Re: King Devens, LLC – 57 Jackson Road Biomanufacturing Facility and Amenity Building  
(Parcel ID# 013.0-0021-0100.0)  
IBI Project No. **122047**

King Devens, LLC - 75 Jackson Road Biomanufacturing Facility  
(Parcel ID# 018.0-0021-1000.0)  
IBI Project No. **122047**

IBI Placemaking has reviewed the second submittal for 57 Jackson Road Unified Permit Application and 57 JACKSON ROAD - SITE DEVELOPMENT PLANS and 75 Jackson Road Unified Permit Application and 75 JACKSON ROAD - SITE DEVELOPMENT PLANS.

**2. OVERALL LANDSCAPE LAYOUT AND MATERIALS PLAN - L100**

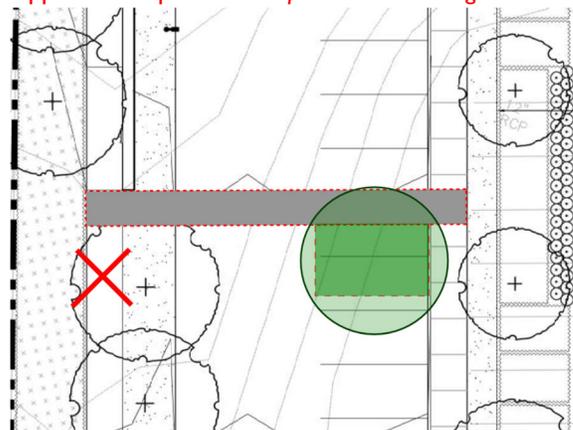
**Applicant Response:** *The redundant pedestrian paving has been eliminated; please refer to the landscape plans.*
- c. Suggest providing a pedestrian crossing in this area to connect to the parking adjacent walkway:

- d. And another planted pedestrian crossing at the point where the walk goes behind the retaining wall. Readjust parking layout to have equally spaced bays between the (now) two tree islands along this side of the building:

**Applicant Response:** *The pedestrian crossing has been adjusted, extending straight across the drive aisle from the southern facade of 57 Jackson (plan left) at the top of the sloping drive aisle.*

*Applicant Response: The pedestrian crossing has been adjusted per IBI suggestion.*
